Dresden Nuclear Power Station, Units 2 and 3
Facility Operating License Nos. DPR-19 and DPR-25
NRC Docket Nos. 50-237 and 50-249

Quad Cities Nuclear Power Station, Units 1 and 2
Facility Operating License Nos. DPR-29 and DPR-30
NRC Docket Nos. 50-254 and 50-265

Subject: Additional Plant Systems Information Supporting the License Amendment Request to Permit Upgraded Power Operation at Dresden Nuclear Power Station and Quad Cities Nuclear Power Station

Attachment D
Additional Plant Systems Information Supporting the License Amendment
Request for Uprated Power Operation
Dresden Nuclear Power Station, Units 2 and 3
Quad Cities Nuclear Power Station, Units 1 and 2
(Non-Proprietary Version)

Figure 2
Dresden and Quad Cities Short-Term DBA-LOCA
Containment Pressure Response

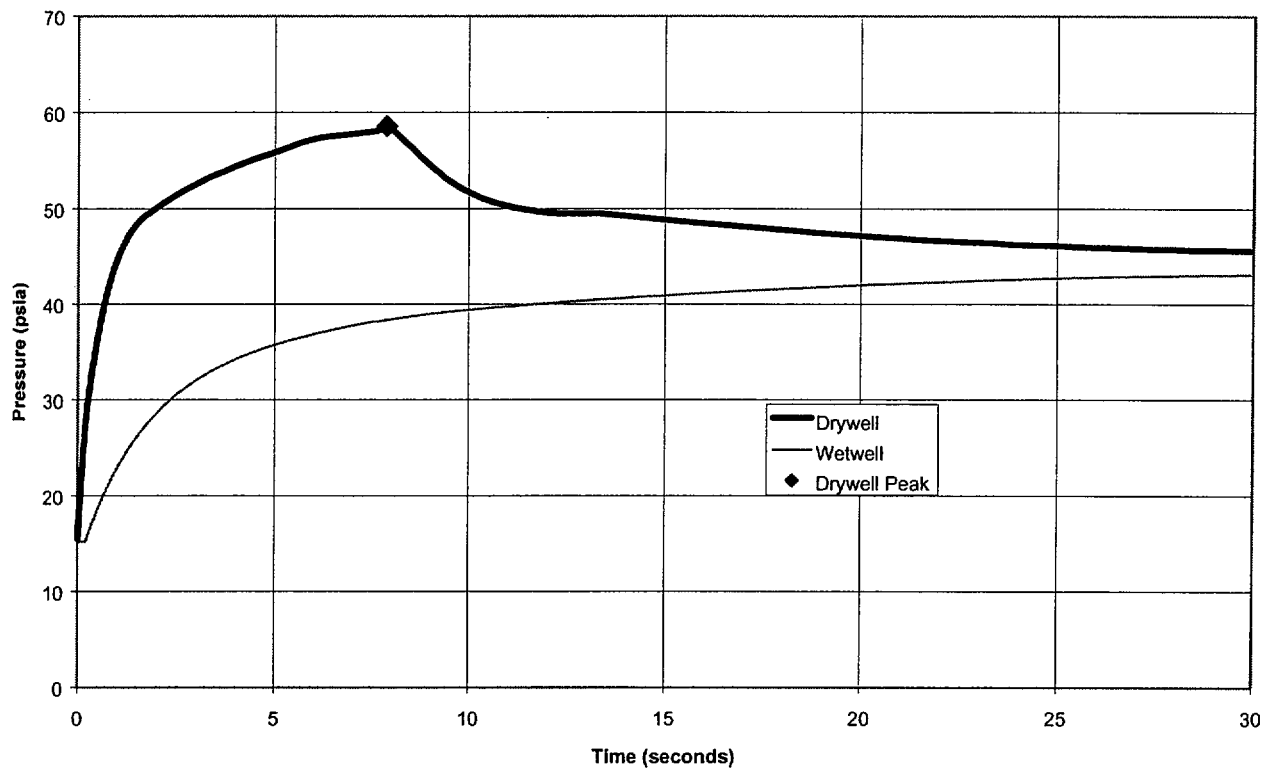
6. *Provide short term and long term results (curves or tables of calculated values as a function of time) of calculations for*

Drywell short term pressure and temperature are provided in Figures 2 and 3. Suppression pool short term temperature is provided in Figure 3. Wetwell atmosphere short term pressure and temperature are provided in Figures 2 and 3. Suppression pool long term temperature is provided in Figures 5 and 9. Wetwell atmosphere long term pressure and temperature are provided in Figures 4,5,8, and 9. Notes for the figures are provided in Table 1.

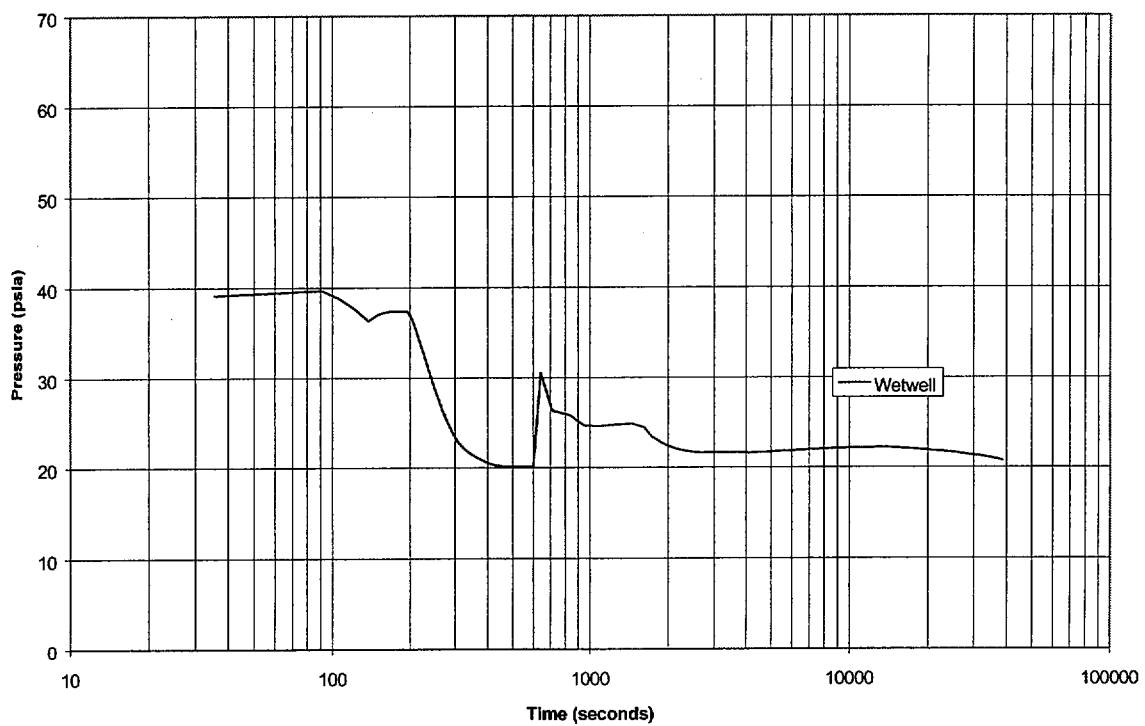
If the long term calculation results are different from those used for calculating NPSH, provide the suppression pool long term temperature and wetwell atmosphere long term pressure and temperature used for the NPSH calculation.

Figures 6,7,10, and 11 provide the curves showing the wetwell atmosphere pressure and temperature and the suppression pool temperature used for the net positive suction head (NPSH) calculation. As noted in Table 1, appropriate assumptions were used to minimize the containment pressure available and maximize the required NPSH.

Figure 12
Hydrogen Generation Rate in Containment Following Loss of Coolant Accident

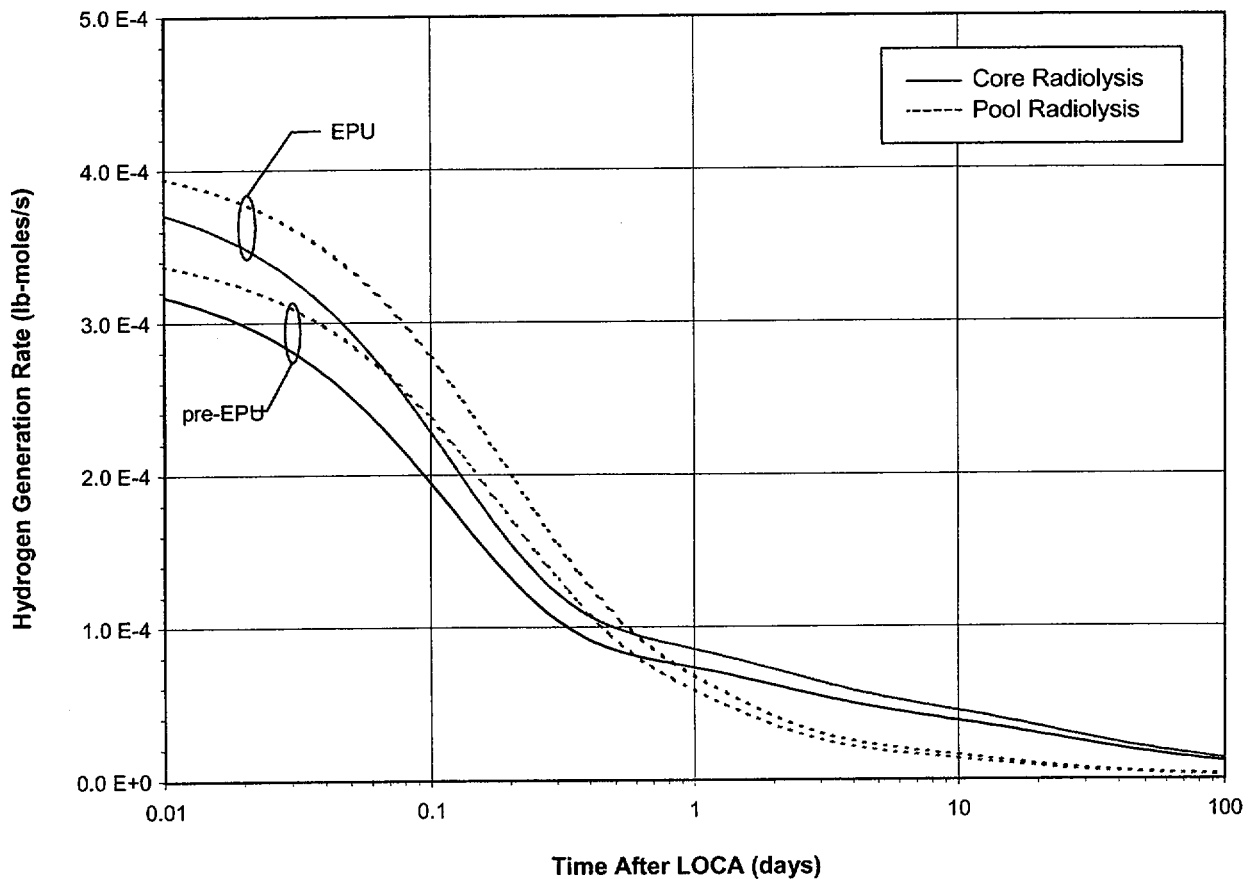
12. Section 4.7 on post-LOCA combustible gas control notes margin changes in various parameters associated with the EPU and additional impact of GE14 fuel introduction on metal-water hydrogen production. Provide long term results (curves or tables of calculated values as a function of time) of calculations for

Hydrogen production is provided in Figure 12. Oxygen production is not specifically presented, but equals one half of the hydrogen production.
